**UNITED STATES
NUCLEAR REGULATORY COMMISSION**
REGION II
245 PEACHTREE CENTER AVENUE NE, SUITE 1200
ATLANTA, GEORGIA 30303-1257

**SUBJECT: CRYSTAL RIVER NUCLEAR PLANT - SPECIAL INSPECTION REPORT
05000302/2009007**

The purpose of this inspection was to examine activities associated with the delamination identified in the Unit 3 containment. The inspection was conducted in accordance with the Special Inspection charter issued by the Region II Administrator on October 13, 2009. As part of the inspection, the NRC examined your evaluation of extent of condition, your evaluation of root cause, and your planned corrective action for continued operability. The inspectors interviewed personnel and conducted plant walk downs, including visual examination of accessible portions of the outside and inside surfaces of the containment.

Figure 5.2.1 Tendon Pattern at SGR Opening and Delamination Profile

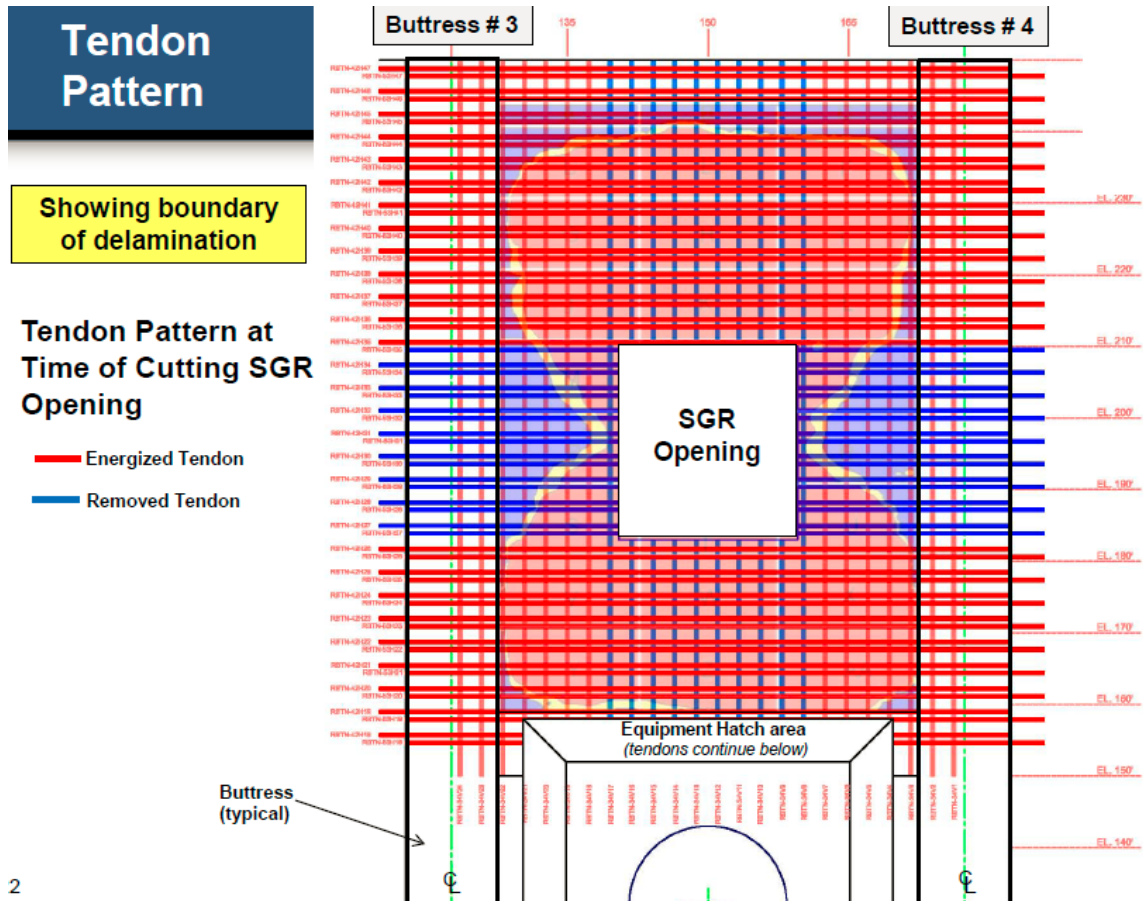
impulse response non-destructive testing technique with confirmatory core boring and boroscopic examinations, determined that the extent of the delamination was limited to Bay 3-4 corresponding to an approximately 60 ft wide by 82 ft high hourglass-shaped area, which included the SGR construction opening, between Buttresses 3 and 4, extending from above the equipment hatch to approximately ten ft below the bottom of the ring girder. The tendon pattern at the SGR opening and the hourglass delaminated boundary is shown in Figure 5.2.1.

Figure 5.2.2 Bay 3-4 midline vertical profile of radial displacements during progressive SGR detensioning (Note that displacements are plotted to an exaggerated scale)

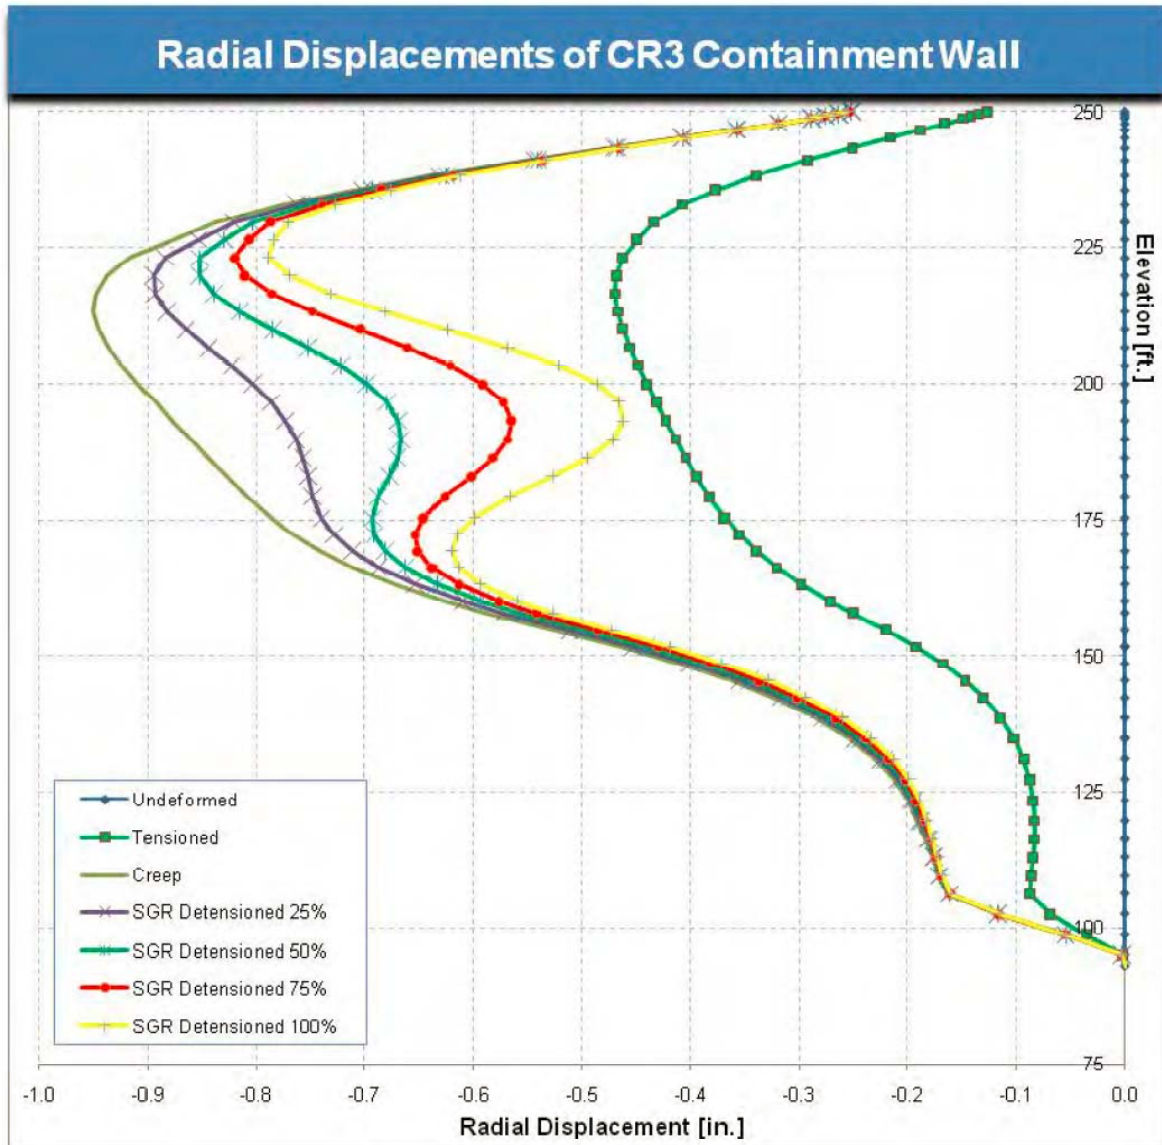
In conclusion, the licensee's root cause evaluation determined that the immediate technical root cause of the delamination event was the redistribution of stresses, as a result of the SGR containment opening activities, resulting in additional stress beyond original containment design. The condition exceeded the fracture capacity/tensile strength of the concrete resulting in cracking along the high stress plane connecting the horizontal tendons. As the cracks propagated and joined, delamination occurred over a wide area. Evaluation of the contributing failure modes identified only one practical technical root cause subject to licensee's control, and that was inadequate scope/sequence of tendon detensioning used in the SGR outage. The licensee stated that the fracture-based computer simulation effort and post-event research by its contractor highlighted the inability (or limitation) of standard industry accepted analysis tools to predict delamination.
